Re: Turkey Point Units 3 and 4  
Docket Nos. 50-250 and 50-251  
License Amendment Request No. 178 - Spent Fuel Pool Boraflex Remedy  
Response to NRC Request for Additional Information

Attachment 1  
Florida Power and Light Company (FPL) Response to  
NRC Request for Additional Information Dated August 8, 2006  
Regarding License Amendment Request No. 178  
Spent Fuel Pool Boraflex Remedy

Attachment 2  
Florida Power and Light Company Response to  
NRC Request for Additional Information Dated October 24, 2006  
Regarding License Amendment Request No. 178  
Spent Fuel Pool Boraflex Remedy

Figure 2.5.1: METAMIC INSERT

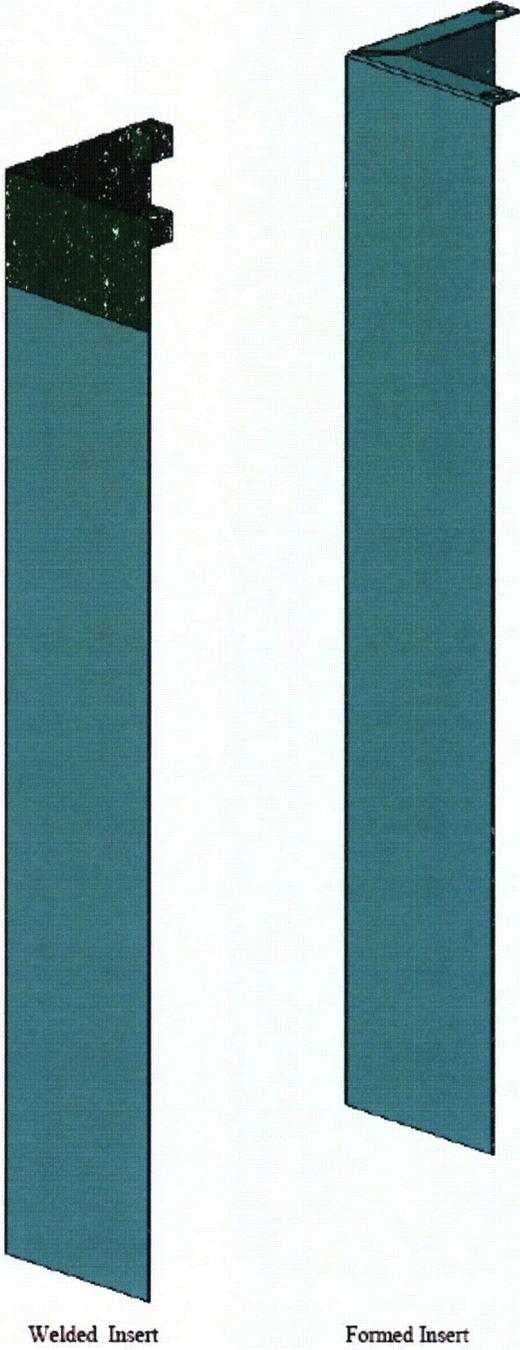
1. The license amendment request proposes use of formed, welded, or a combination of formed and welded inserts. Is this correct for the staff to assume that a combination of formed and welded inserts means that a number of welded inserts and a number of formed inserts may be used? However, if this means that an inset design may consist of welding and forming, please provide a schematic of this insert design.

FPL's response to item 2(a) of the initial RAI states that this license amendment is intended to obtain approval of a formed insert design, a welded design, and a "combination" design incorporating both techniques (i.e., with formed and welded features). The description of formed and/or welded applies to fabrication techniques involving Metamic material. Methods used to attach the Al 6061 head piece to the Metamic panel include welding and other mechanical means<sup>5</sup>. Inserts whose design relies exclusively on welding would be fabricated by longitudinal welding of Metamic panels to form the chevron, with an Al 6061 head piece welded to one end of the chevron. Designs reliant on forming would be fabricated by bending Metamic panels to create the longitudinal chevron shape, with selective bends added at one end to create tabs for handling. Inserts having both formed and welded features (combination-type) might be fabricated by using a longitudinal bend to create the chevron shape, after which a top piece, designed to interface with remote tooling, is welded or otherwise mechanically attached. FPL

has successfully demonstrated the welded fabrication process and has manufactured a number of initial prototypes. However, FPL desires to improve product yield and is continuing to seek a more efficient production method via the formed or combined fabrication process. Regardless of the fabrication technique, all three insert designs are functionally identical in providing Metamic coverage over active fuel. Figure 2.5.1 of Holtec Report HI-2043149 (included in the FPL license amendment request as Attachments 9 and 10) provides graphic images of both the welded and formed inserts. The combined insert design will look more like the welded image in this figure, but with the longitudinal edge formed instead of being welded.

As FPL is proposing to use potentially all of the fabrication processes discussed above and welded prototypes have been fabricated, FPL is also proposing to use a mixture of welded, formed and combination-type Metamic inserts in each spent fuel pool.
